**DEVIATION REQUEST
AND DECISION FORM**

Project Name : The Commons at Falcon Field Deviation No. : 19-00000001

DEVIATION No. 4 – Intersection Spacing (6/2/2023): A deviation from the standards of or in Sections **2.2.5.D** and **2.3.2** of the Engineering Criteria Manual (ECM) is requested. The request is for a deviation from the ECM standard intersection spacing along an Urban Local Street Retail Row Way- east of Kite Place less than the ECM prescribed 175-foot centerline spacing along an Urban Local Street.

Sight Distance Analysis Retail Row/Gryfalcon

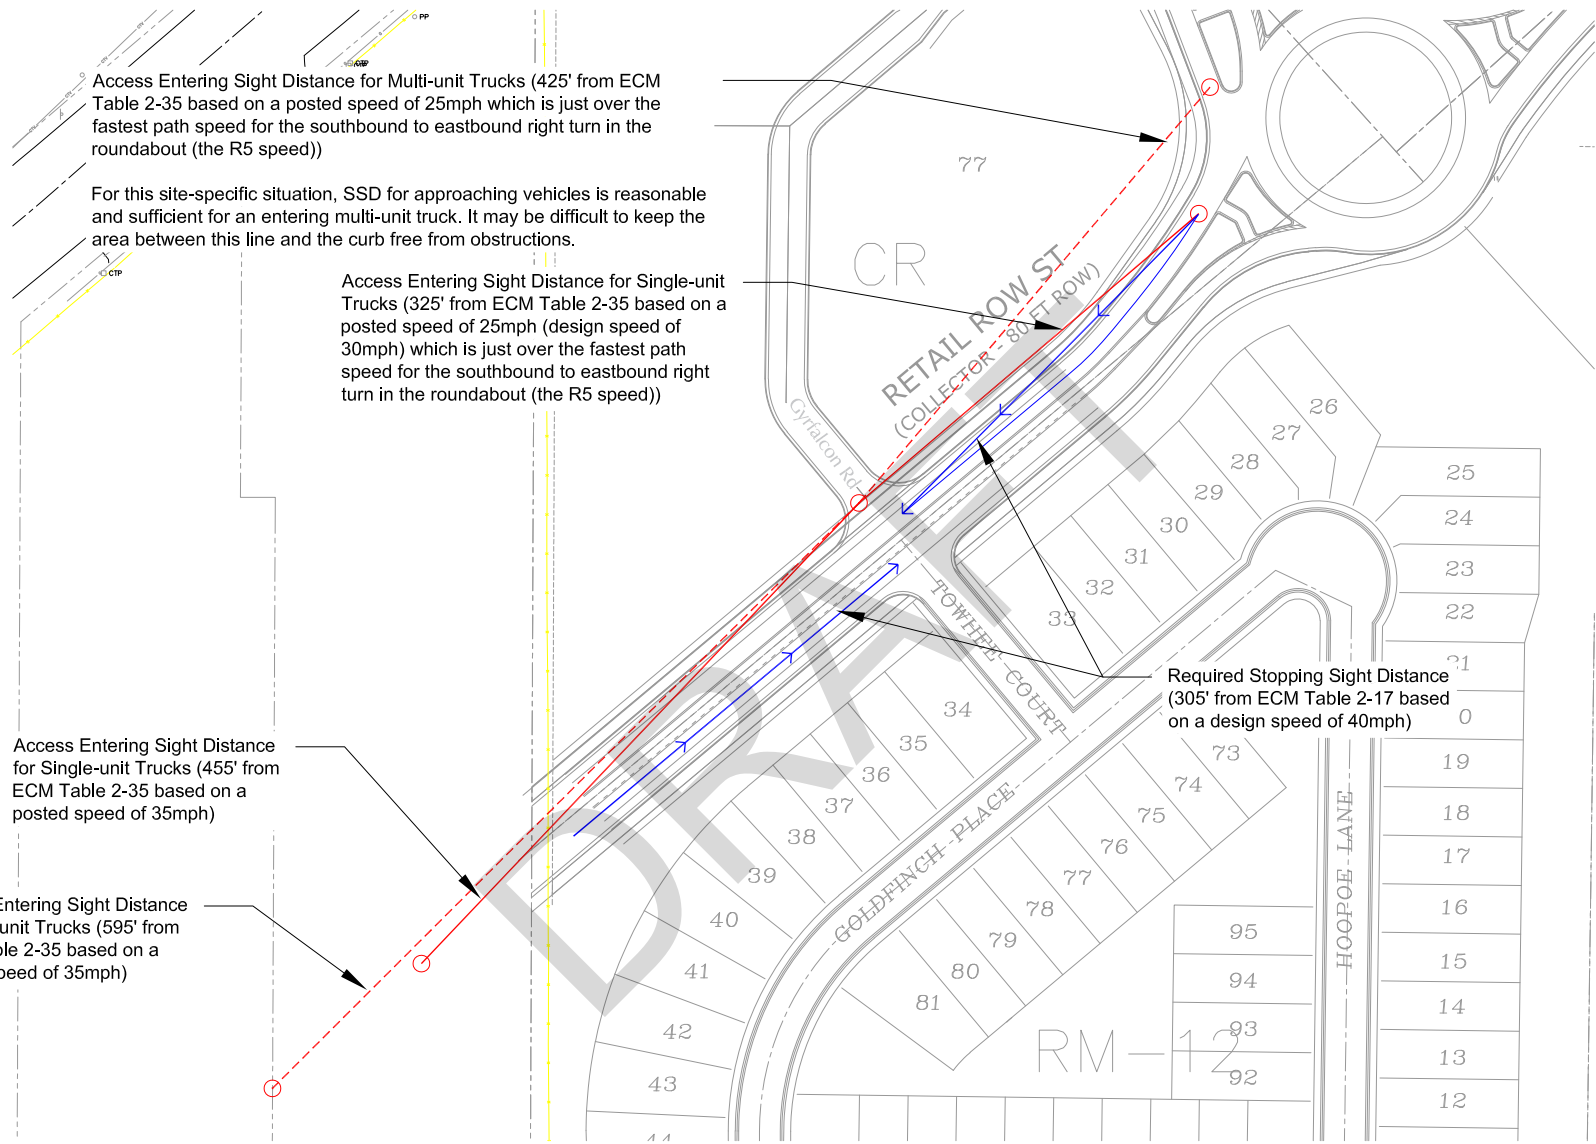
For this site-specific situation, SSD for approaching vehicles is reasonable and sufficient for an entering multi-unit truck. It may be difficult to keep the area between this line and the curb free from obstructions.

Deviation Exhibit G1

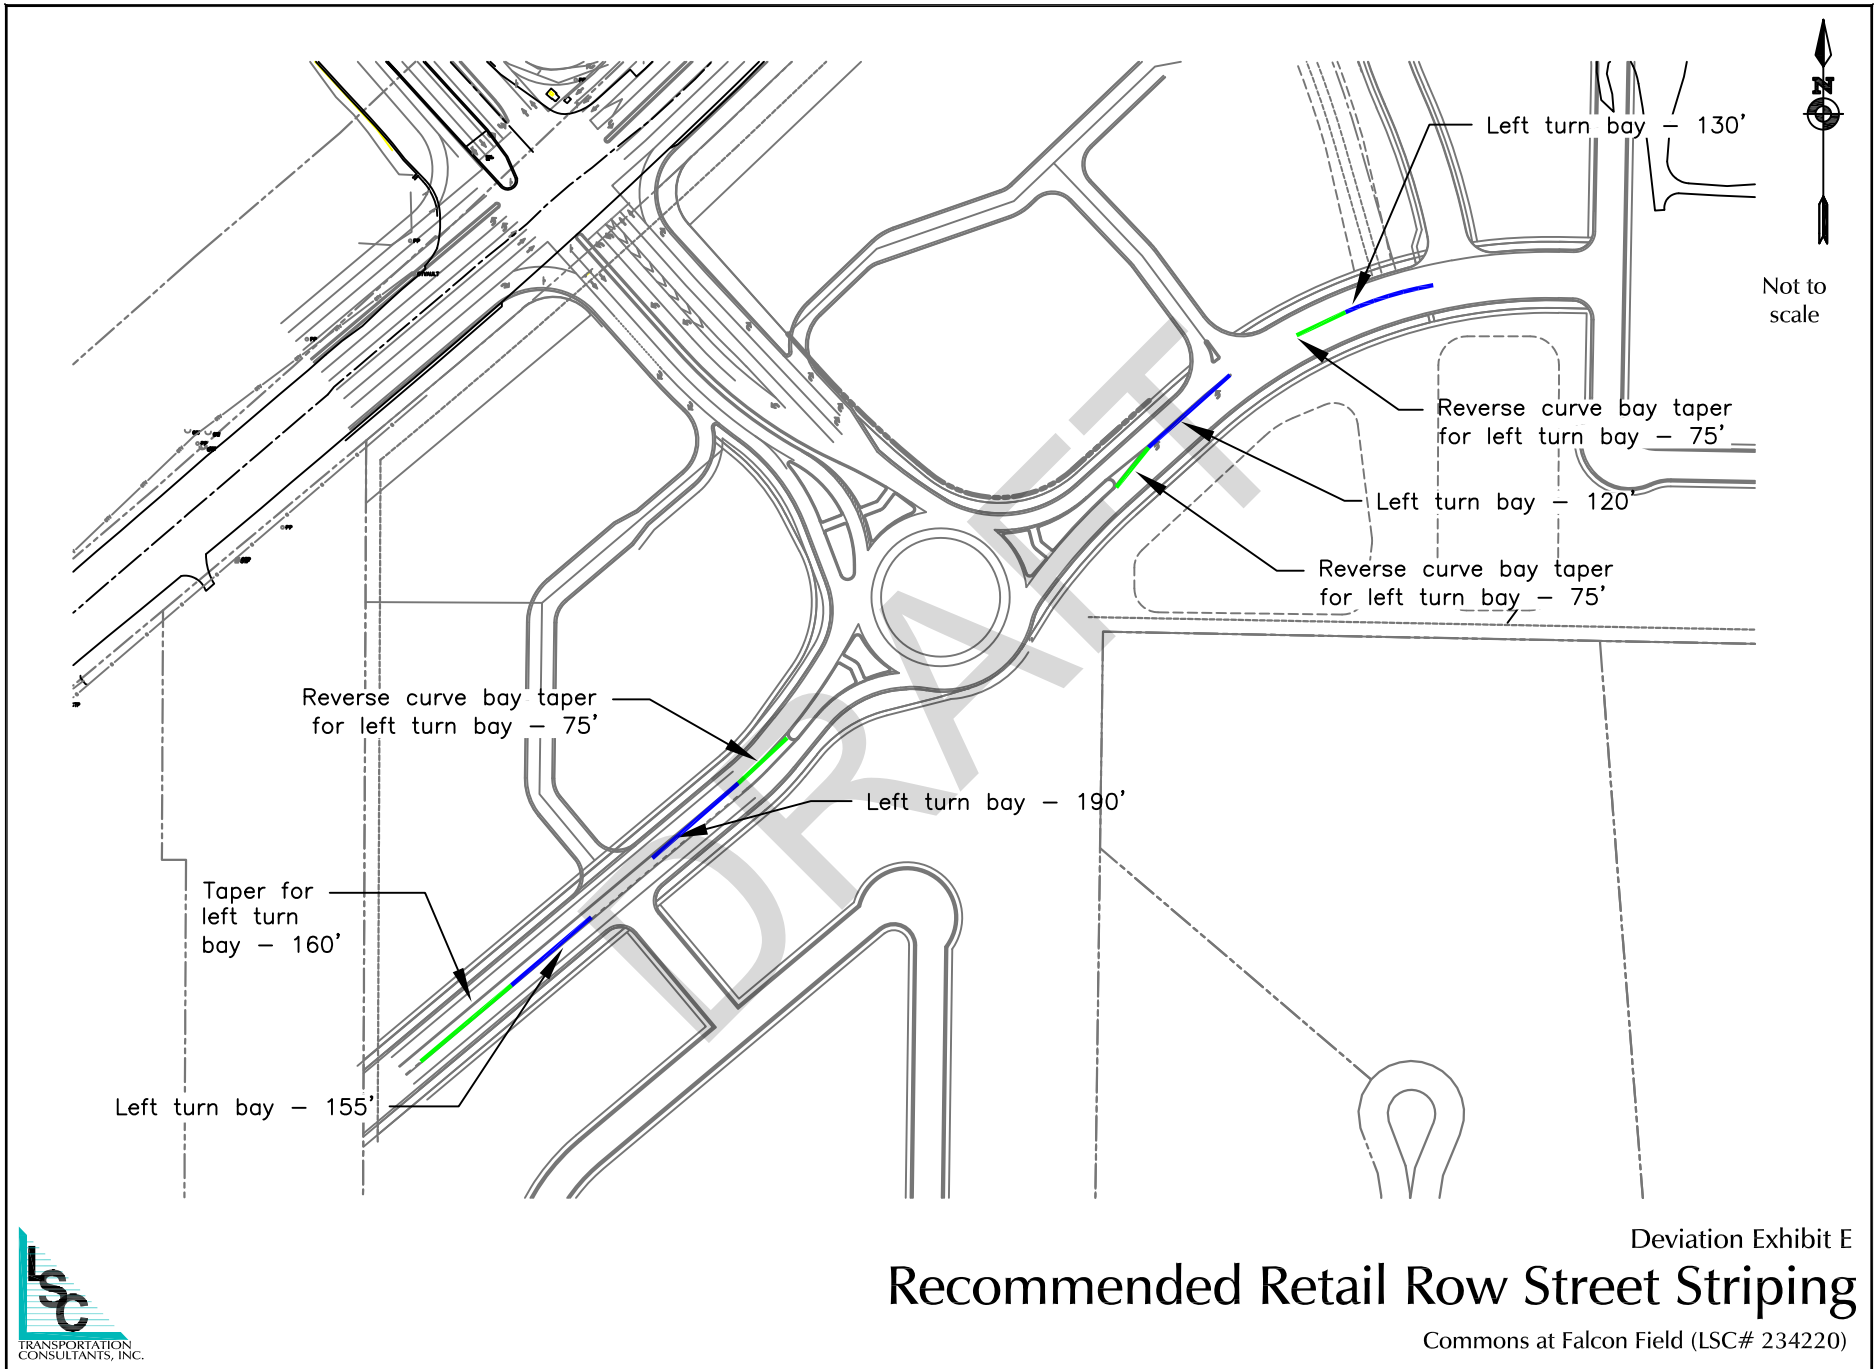
After discussion with the engineering manager and County engineer the proposed intersection spacing would be denied. There is no geographical constraint that precludes the applicant from meeting criteria as this is an undeveloped parcel.

This does not appear to be an obstacle anymore as the channel is intended to be replaced with a storm pipe (box culvert) allowing the use of the land above
